The Big
SHOP DRAWING (SDW)

Project	The Big Business District	S.D/Submittal No.	Rev.
Owner	ROYA Developments	BD-CW-SAMCO-PCO-SDW-STR-055	02
Project Manager	ACE-PM	Date: 16-06-2026	
Supervision Consultant	PRIME CONSULTING OFFICE	Submitted For	
Contractor	SAMCO National Construction	Approval	
		Information

SD Subject	RFT DETAILS OF GROUND FLOOR B3&B4	Action (2)
Location	PART(01)	Approved
Attachment	(1) A3 Sheet	Approved as Noted
		Revise and Resubmit
		Rejected

Drawing title
R.F.T DETAILS OF(ADD-BOTTOM) GROUND FLOOR FOR (B3&B4)-PART (1) AT LEVEL(+214.90) SHEET (11/15)

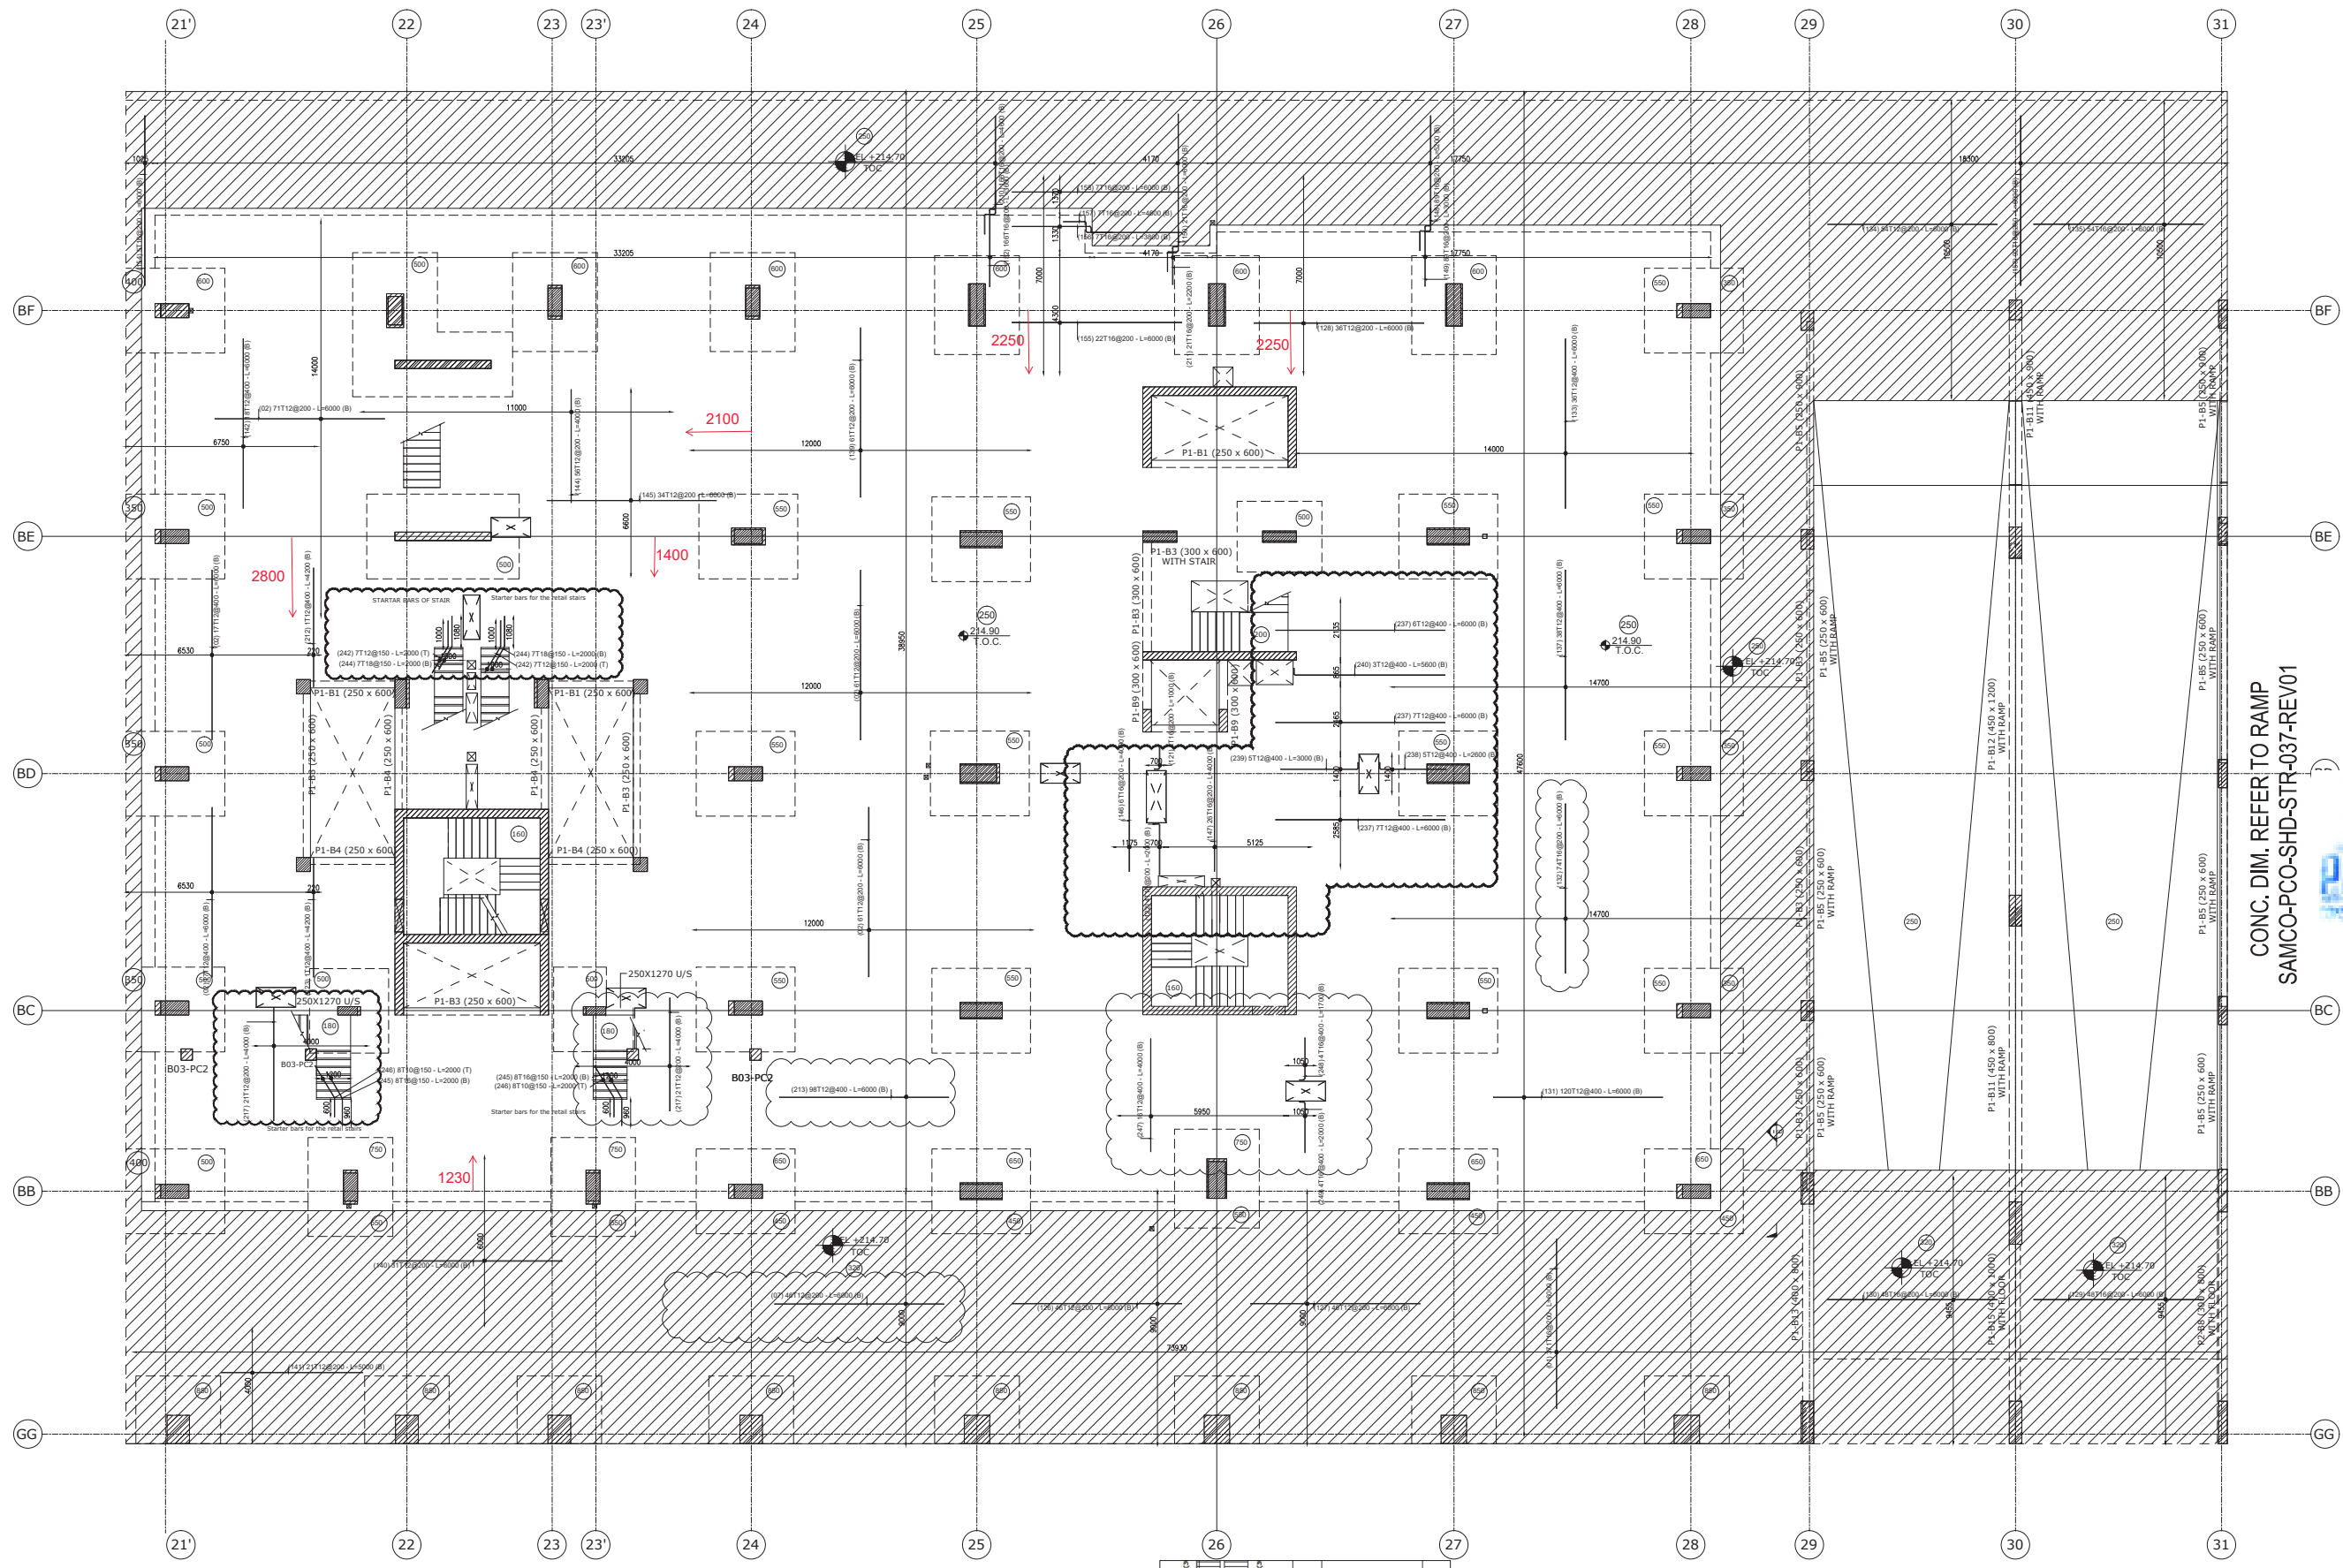
As per the approved comment, only the retail stair shaft openings will be constructed, and the stair itself has not been executed yet. Starter rebars for the retail stairs will also be provided and left ready for future construction, if required.

- Only clouded area are reviewed and approved in this drawing.
- Additional bars should be connected to axis with dimension lines
